PRELIMINARY DRAINAGE REPORT

FALCON MEADOWS AT BENT GRASS

DATE:
August 5, 2020
Revised December 2020
Revised February 2021
Revised April 2021
Revised June 2021

PUDSP-20-005

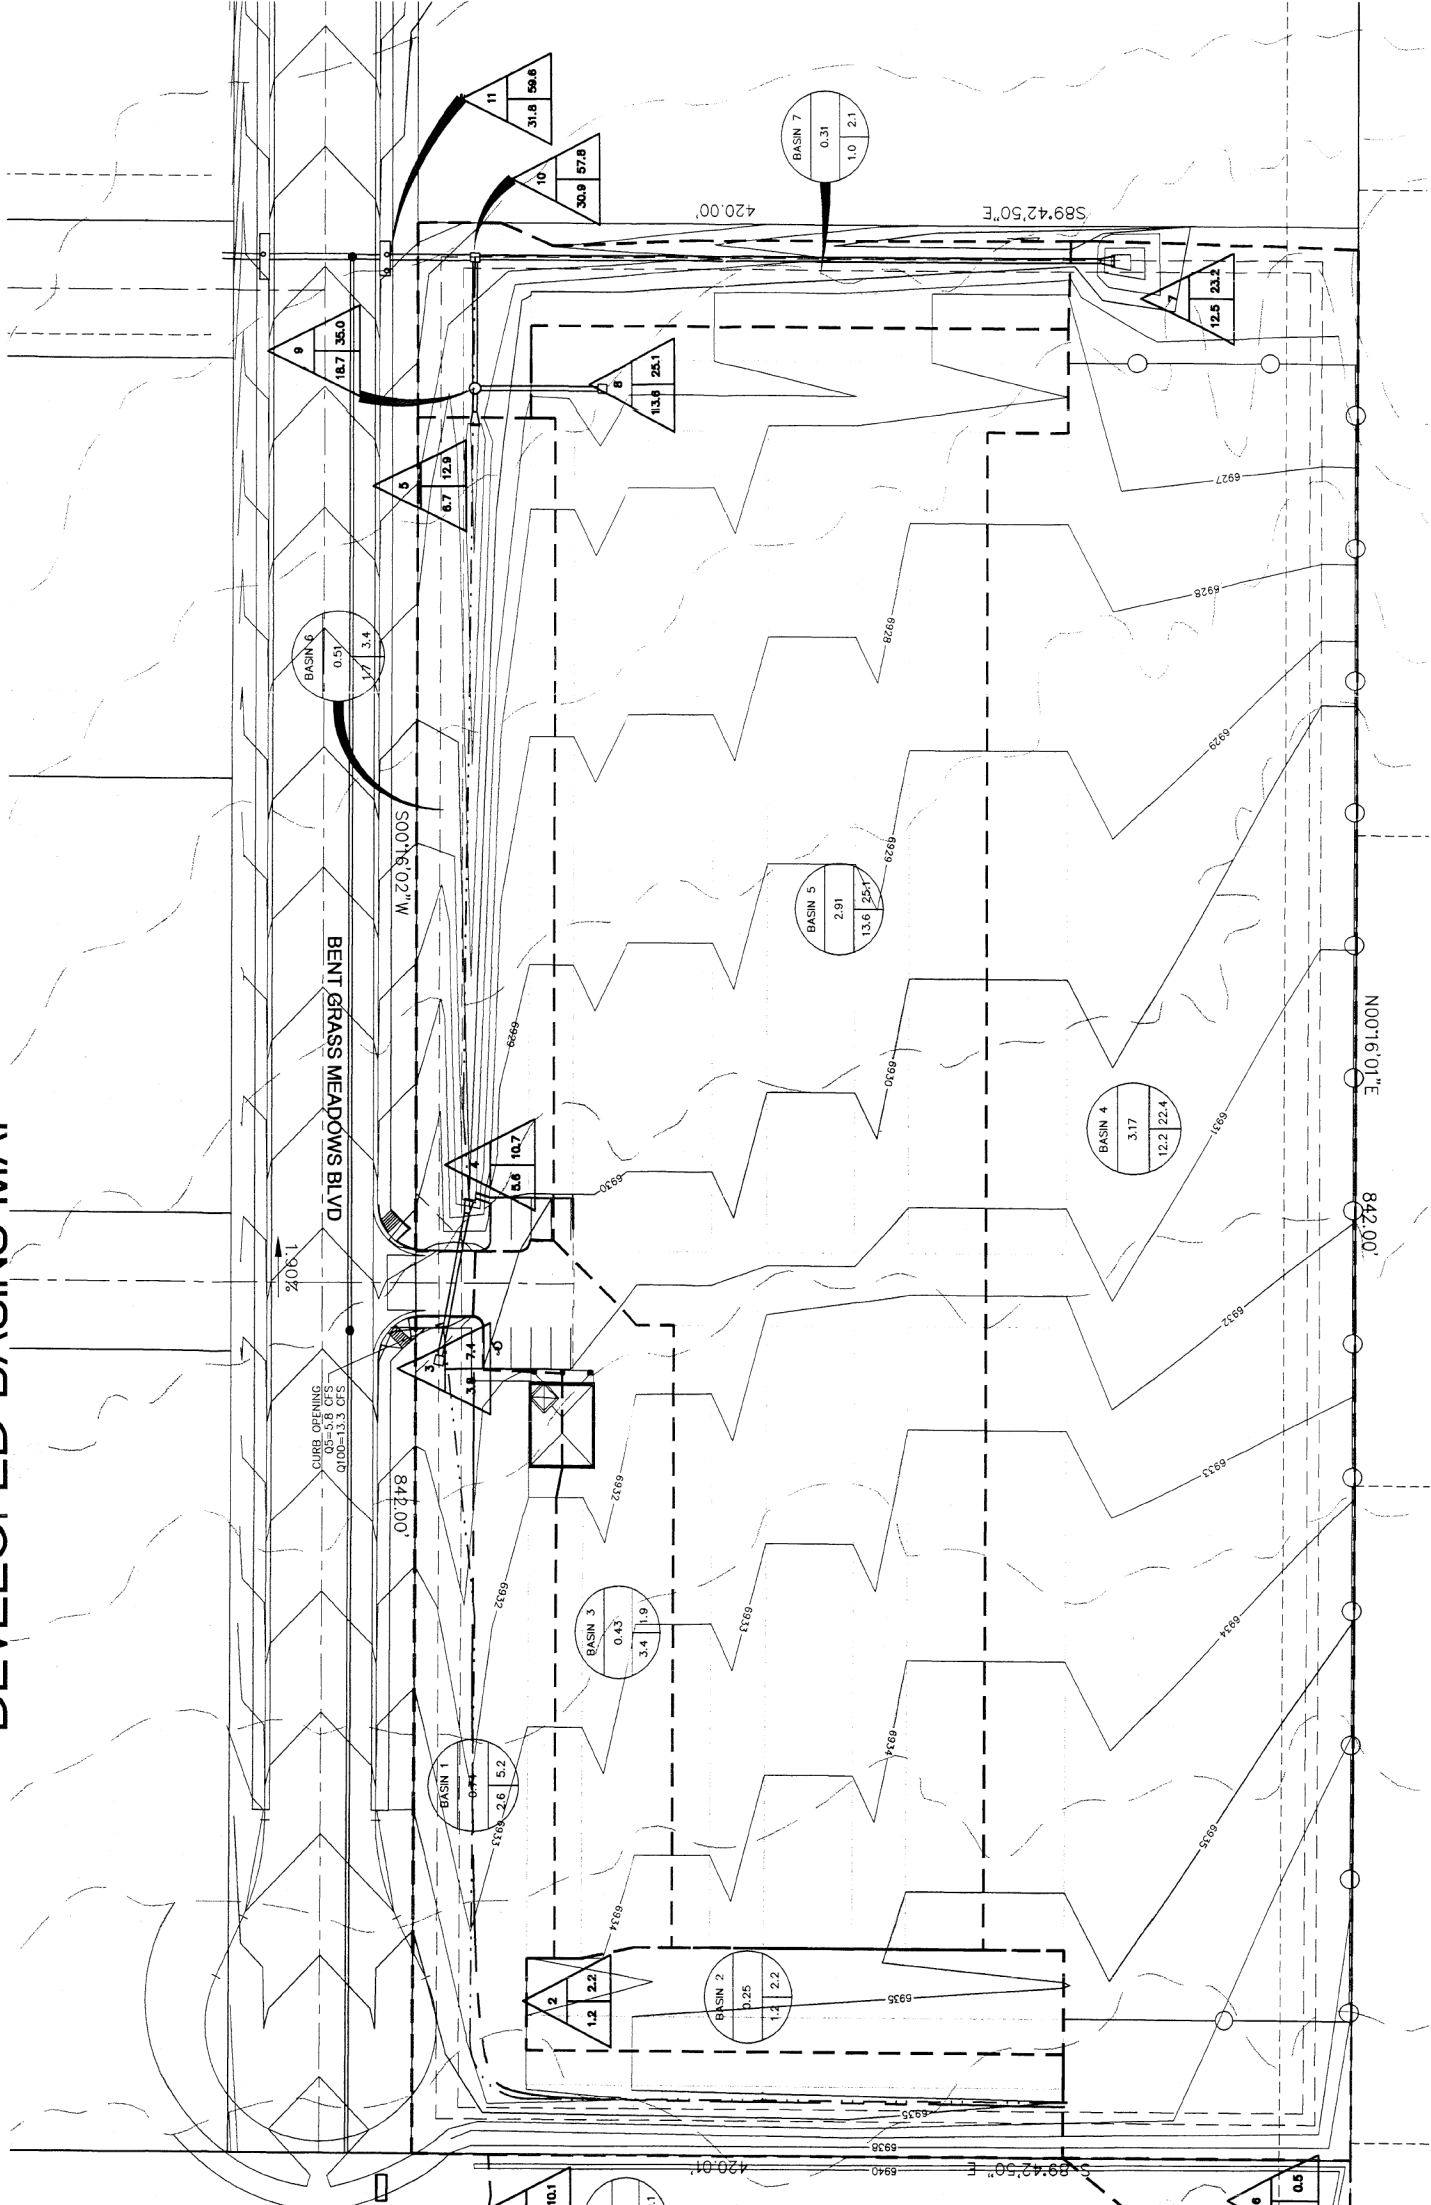
Add the marked up figures from the MDDP
